GROUP	MODEL
Safety Recall Campaign	2014-2016MY Cadenza (VG)
NUMBER	DATE
SC284VG	June 2024

HECU MULTI FUSE REPLACEMENT (SC284VG)

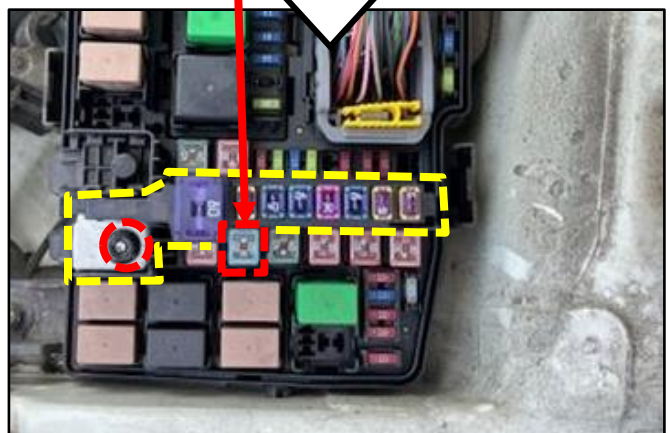
- 4a. Locate the Multi Fuse (A) for ABS1 and loosen the 10mm Multi Fuse retaining nut (B) and remove the Multi Fuse.

- 5a. Remove the existing HECU ABS2 30A fuse (C).

- 4b. Install the new Multi Fuse (A) and tighten the retaining nut (B).

- 5b. Install new amperage fuse:

- ABS2 fuse (C) → new 20A

Tightening torque for retaining nut (B):
7.2 - 8.7 lb.ft (9.8 - 11.8 N.m)
